10/13/95	ADDENDUM 1
DATE	REVISION
STATE OF HAWAII DEPARTMENT OF TRANSPORTATION HIGHWAYS DIVISION ROOF WALKWAYS COMMON WORK H-3 FINISH (UNIT III) FAIP NO. I-H3-1(75), UNIT III T.K. TUNNEL/ACCESS ROADS SCALE: 1" = 20' DATE: JUN 1995	
SHEET NO. 7A1	OF 5 SHEETS

STATE OF HAWAII
DEPARTMENT OF TRANSPORTATION
HIGHWAYS DIVISION
**ACCESS OPENING SAFETY
RAILING — HALAWA**
COMMON WORK
H-3 FINISH (UNIT III)
FAIP NO. I-H3-I(75), UNIT III
T.K. TUNNEL/ACCESS ROADS
SCALE: NONE
DATE: JUN 1995
SHEET NO. 7SI OF 6 SHEETS

POTABLE WATER TANK

DETAIL 2
SCALE: NONE
7S3 7S3

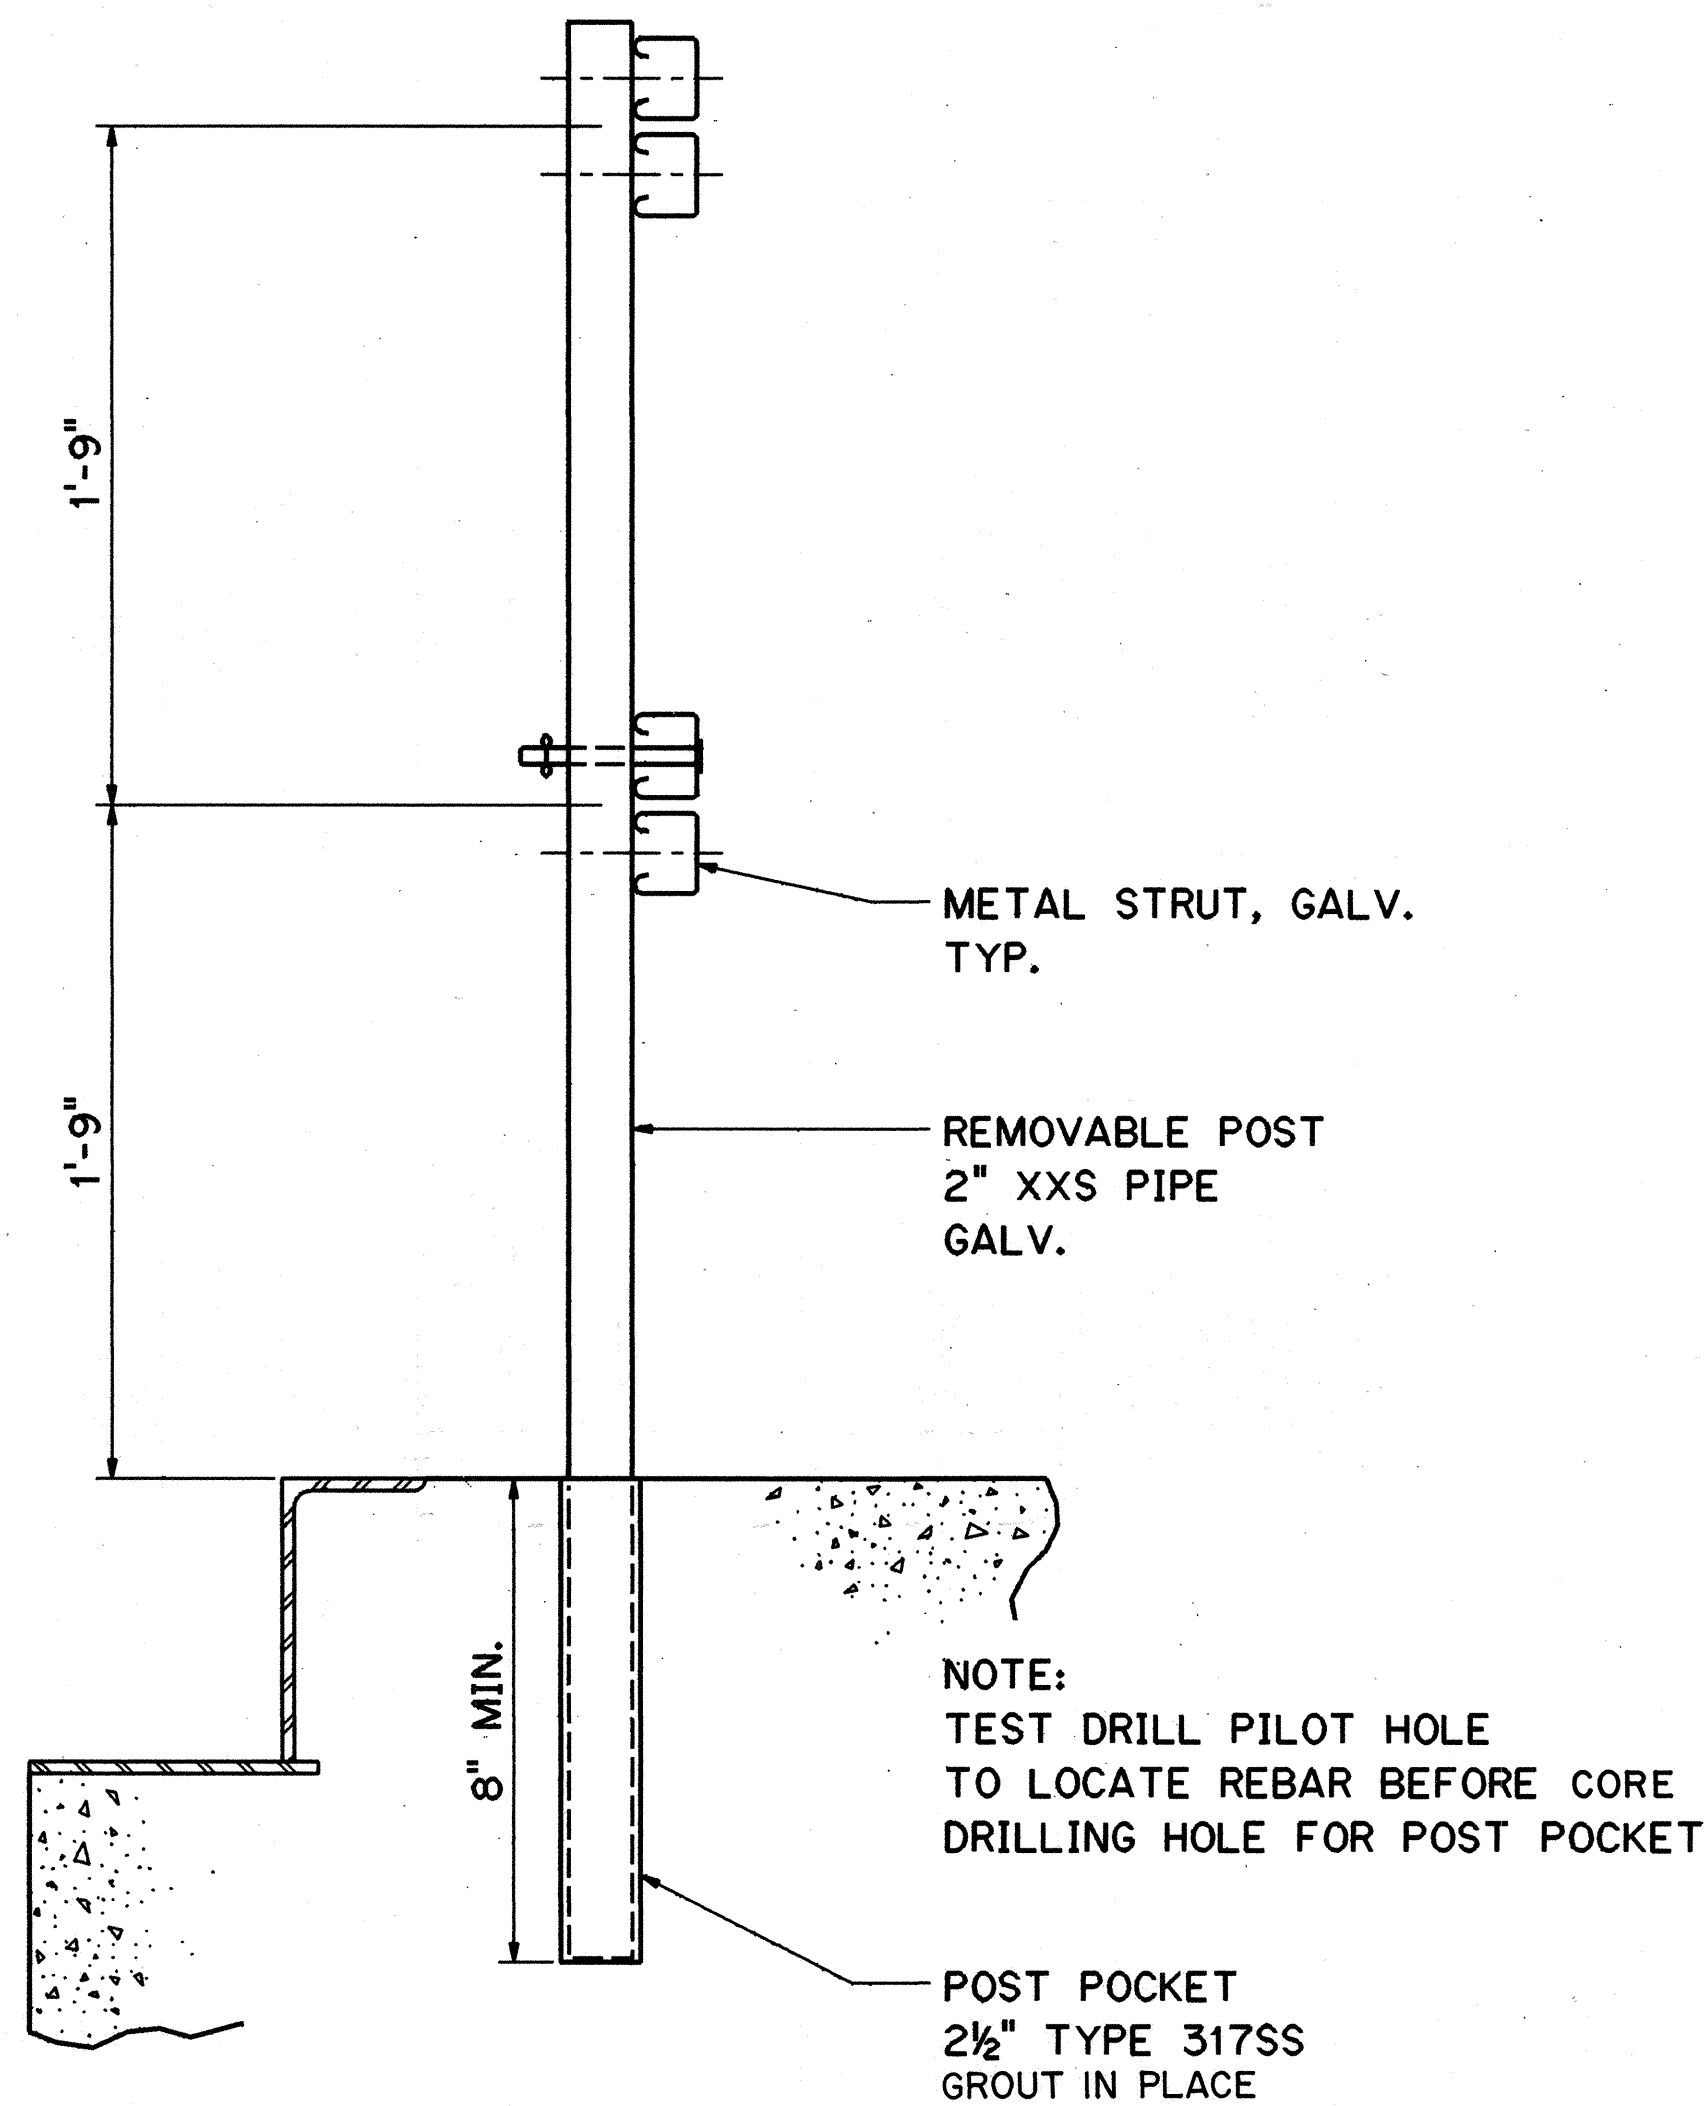
10/27/95	ADDENDUM 2-ADDED POST POCKET NOTE
10/13/95	ADDENDUM 1
DATE	REVISION
STATE OF HAWAII DEPARTMENT OF TRANSPORTATION HIGHWAYS DIVISION	
ACCESS OPENING SAFETY	
RAILING - DETAILS	
COMMON WORK	
H-3 FINISH (UNIT III)	
FAIP NO. I-H3-1(75), UNIT III	
T.K. TUNNEL/ACCESS ROADS	
SCALE: NONE	DATE: JUN 1995
SHEET NO. 7S3	OF 6 SHEETS

PLAN

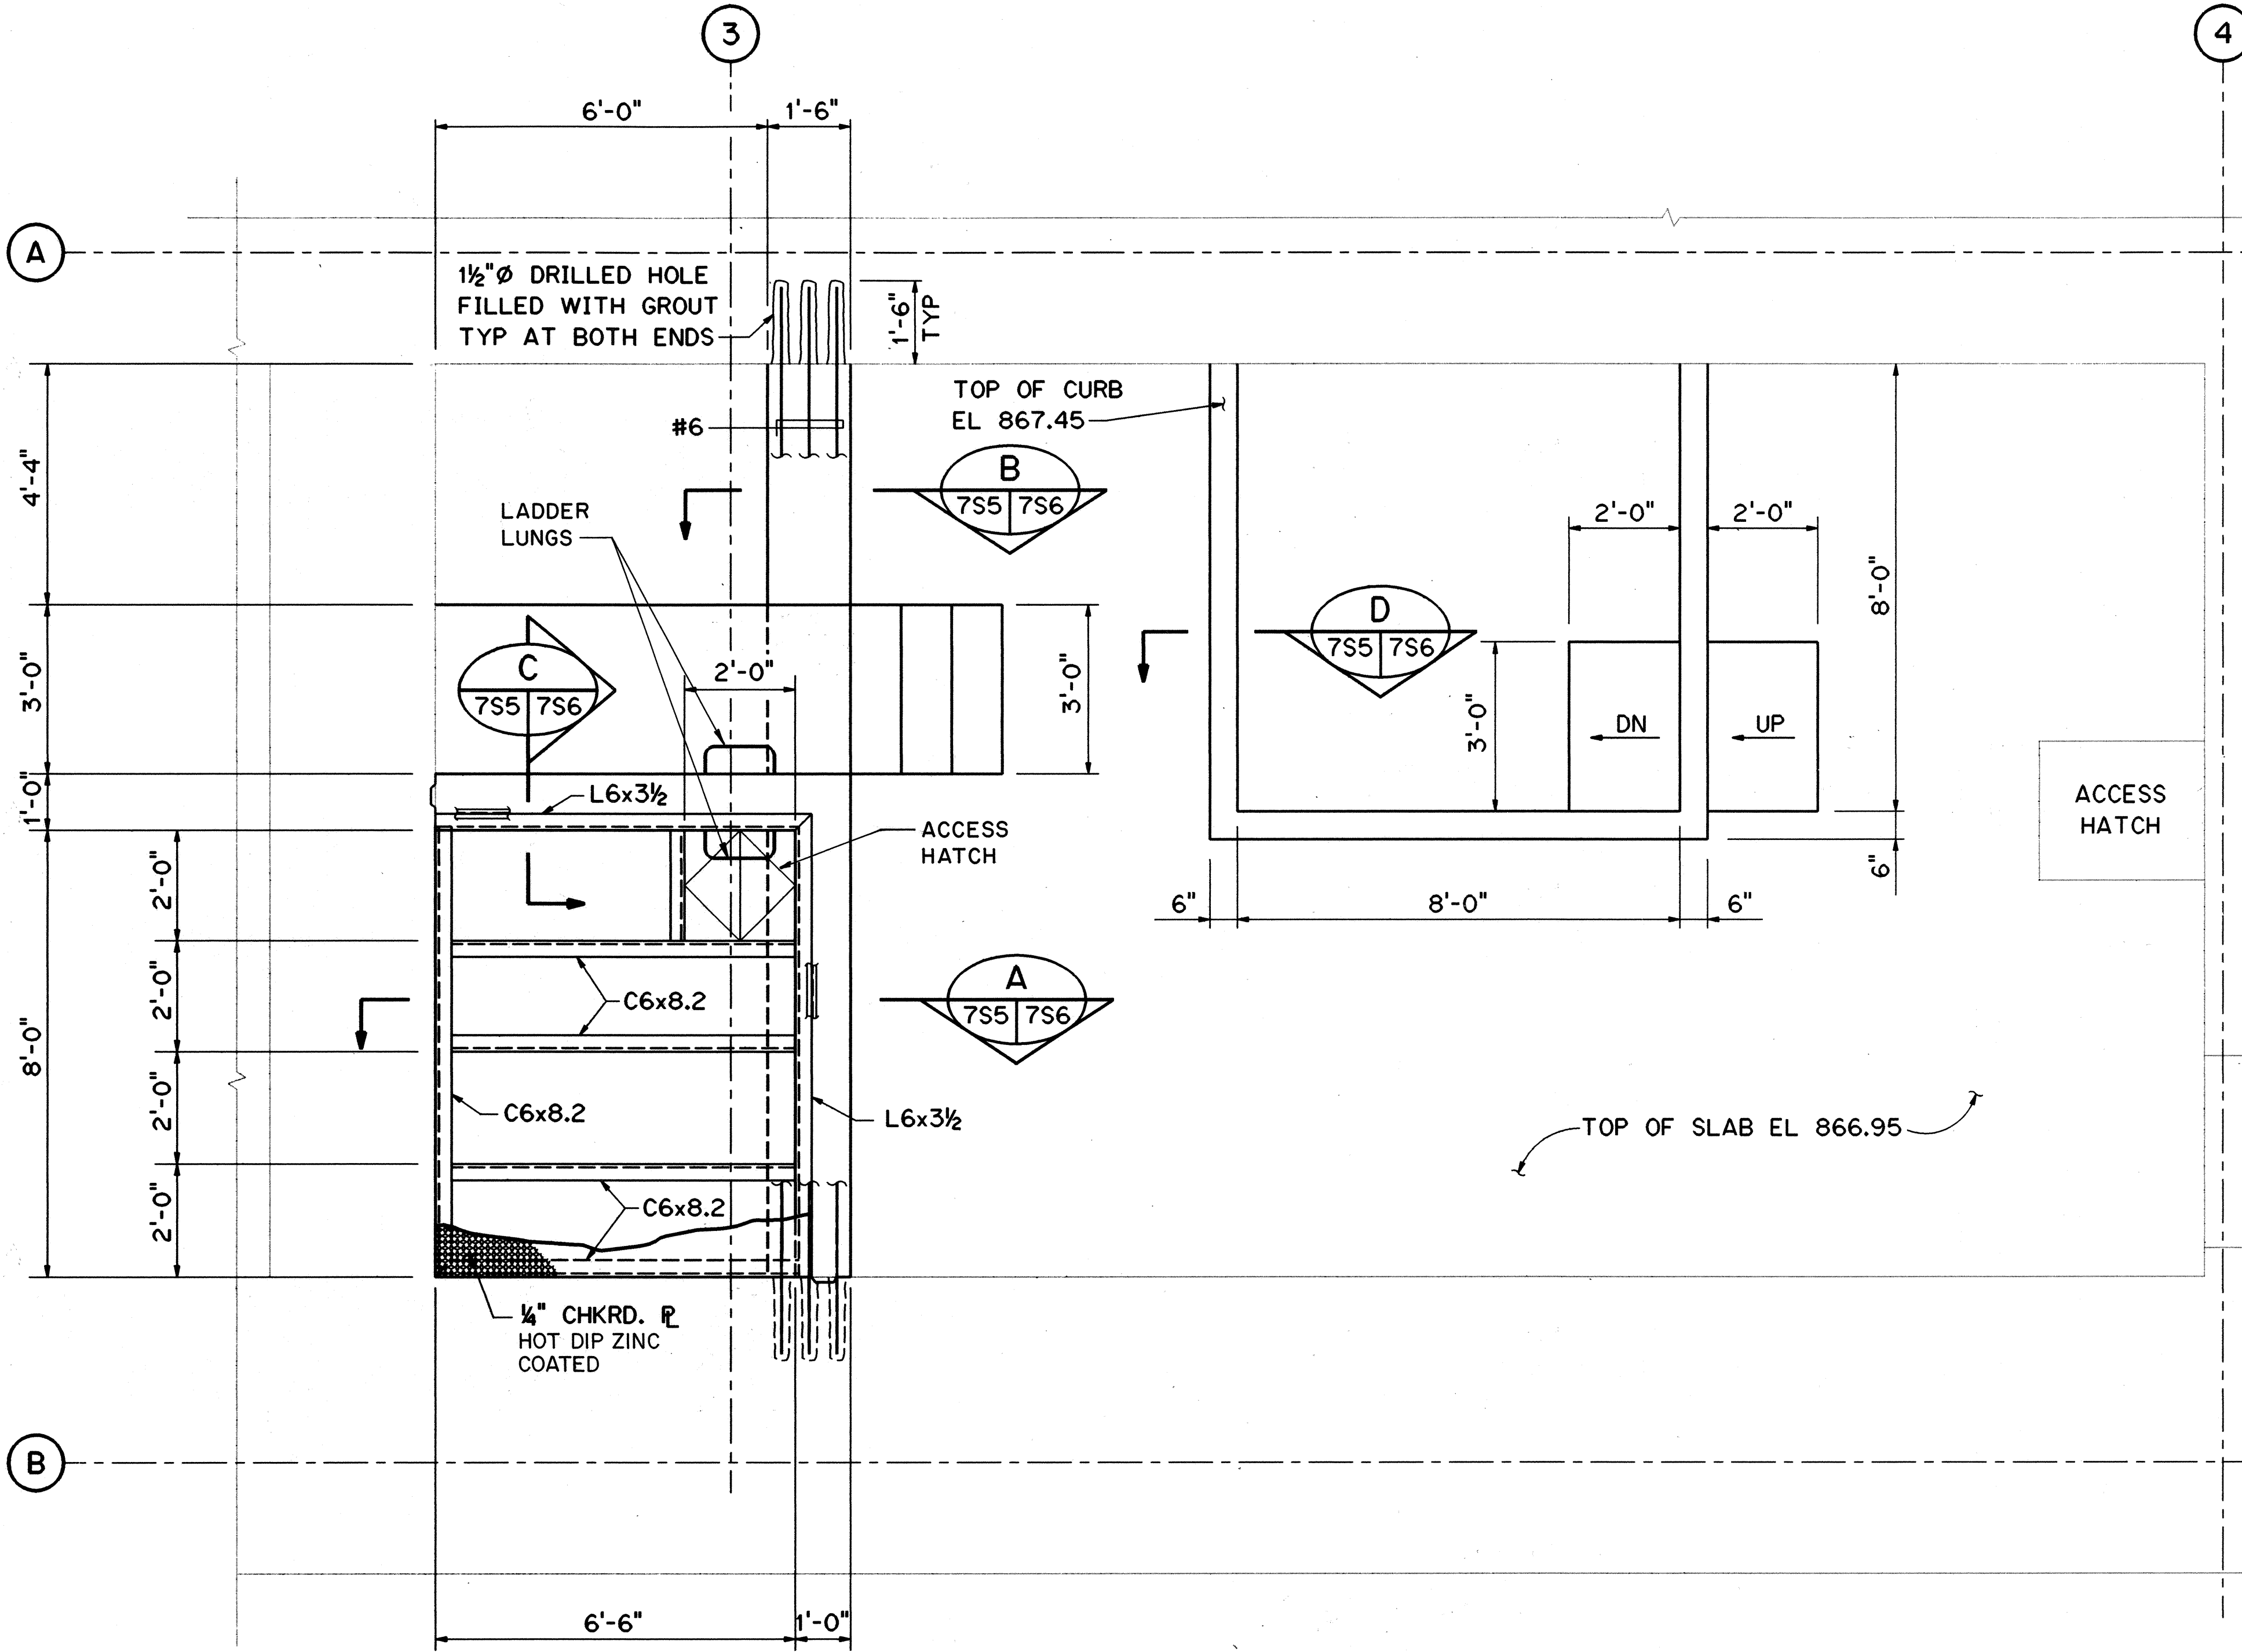
DATE	REVISION
10/27/95	ADDENDUM 2-ADDED HOT DIP ZINC COATED TO CHKRD PLATE
10/13/95	ADDENDUM 1

SECTION A

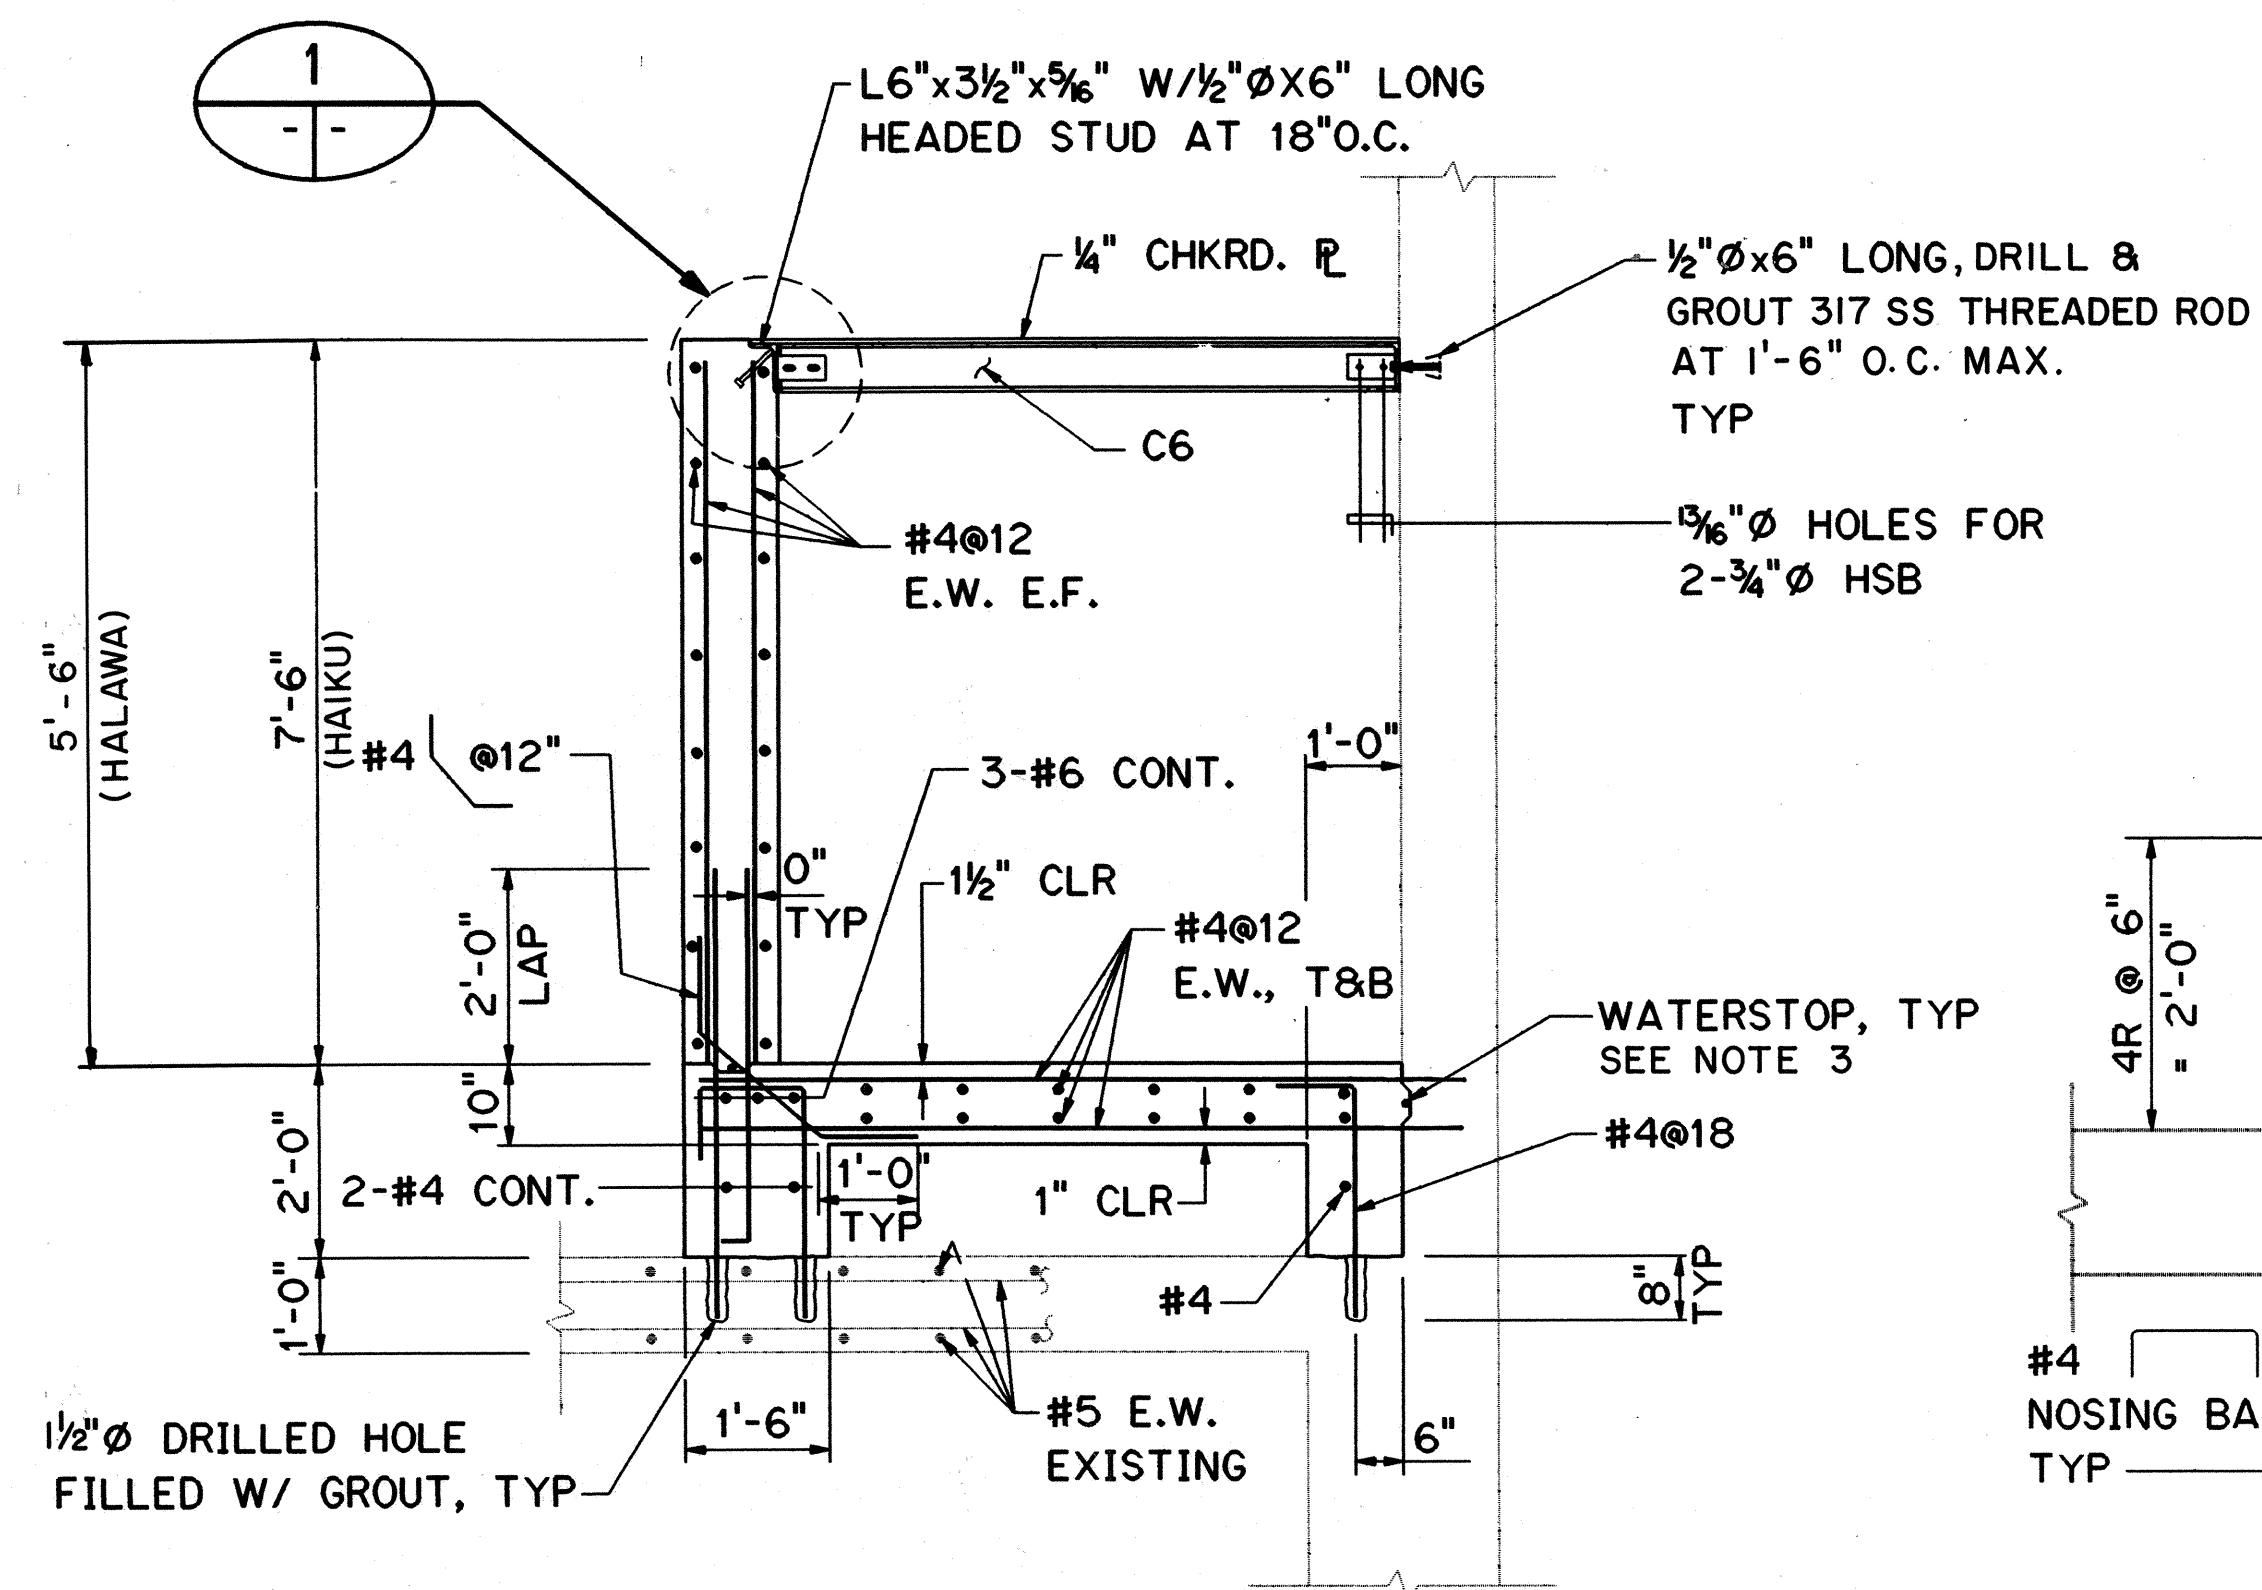
2/3/97	DCN 75-011: REVISED WATER TANK HEIGHT (SECTION A) PER RESPONSE TO RF1 # 4097-177
10/13/95	ADDENDUM 1
DATE	REVISION
